April 5, 2006

Note To: J. Wermiel
From: E. Throm 
Subject: SSIB POST-LOCA CONTAINMENT REPORT

Figure 28: *NPSH Margin Sample Calculation, Case 1 ABA M*

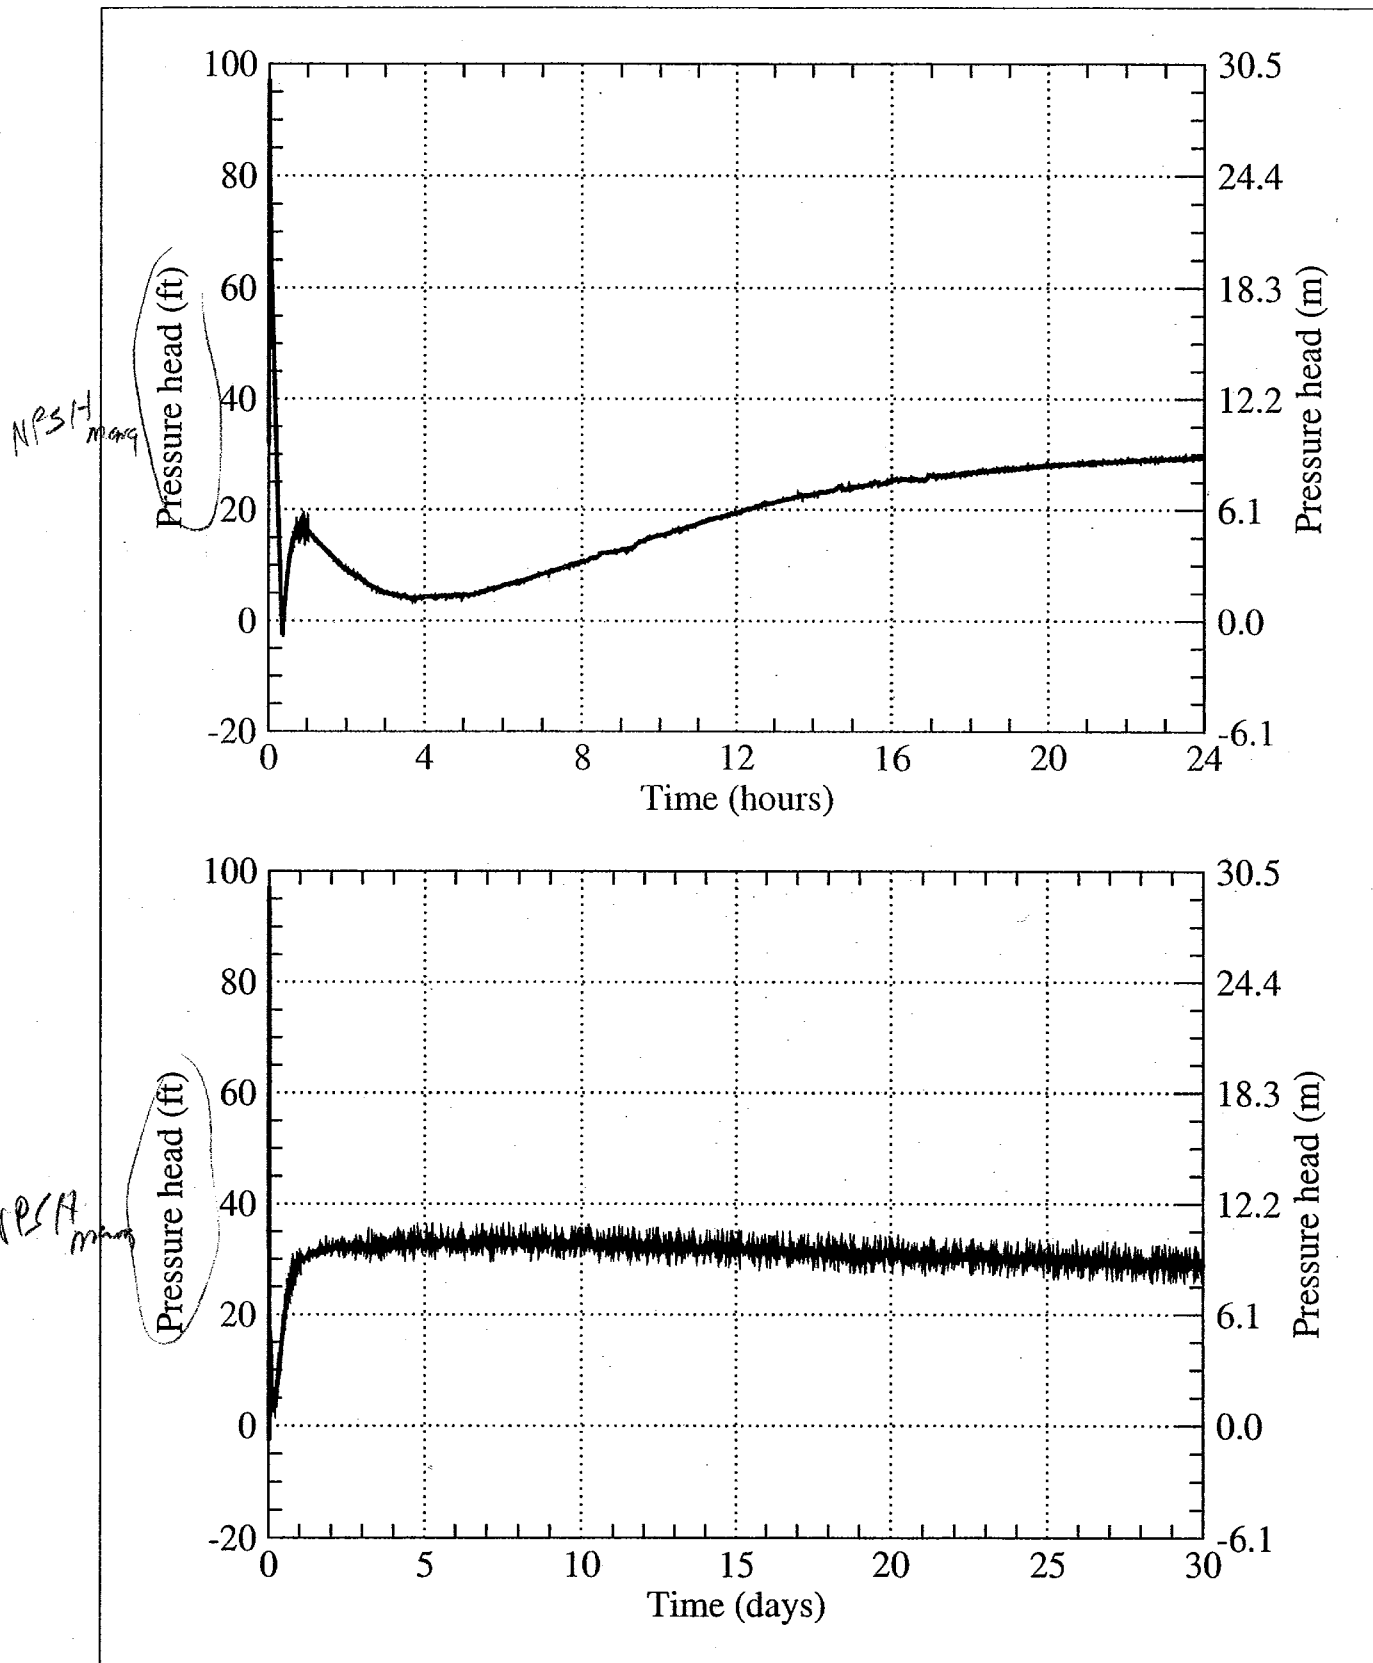
isn't this the most critical time?
How accurate is water level?

then why are they doing calculation?
